1 **REFERENCE:** **YEC response to YUB-YEC-01-004 and YUB-YEC-01-080, PDF**
2 **pages 225-229 and 552-556**

3
4 **ISSUE:** Disallowed portion of capital projects added to rate base resulting in
5 2023 and 2024 rate increases: WH2 Uprate Construction and
6 Engineering (WH2) (rate base addition of \$7.078 million to 2021 GRA
7 approved); WH4 Servomotor Replacement (WH4) (rate base addition
8 of \$0.789 million to 2021 GRA approved) and Enterprise Asset
9 Management System Purchase and Implementation Project (EAM)
10 projects

1 **Part 1: Board Findings Issue Information Comparison – WH2 Uprate Project**

Appendix A: WH2 Uprate Project – Additional Information on Budget Development

Figure 1: Section drawing of the WH2 turbine showing major components that will be refurbished (green) and replaced (red).

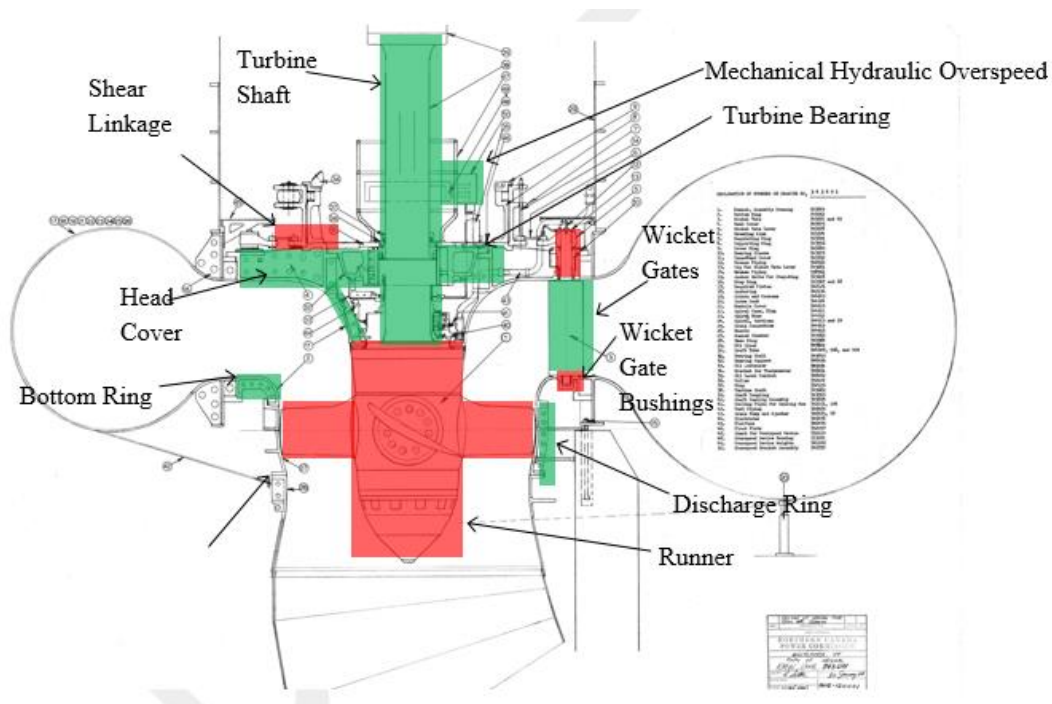
1. Replacement and refurbishment of the identified T&G components based on the results of the detailed engineering analysis. Major parts to be replaced and refurbished on the turbine and generator are shown in Figures 1 and 2 below.
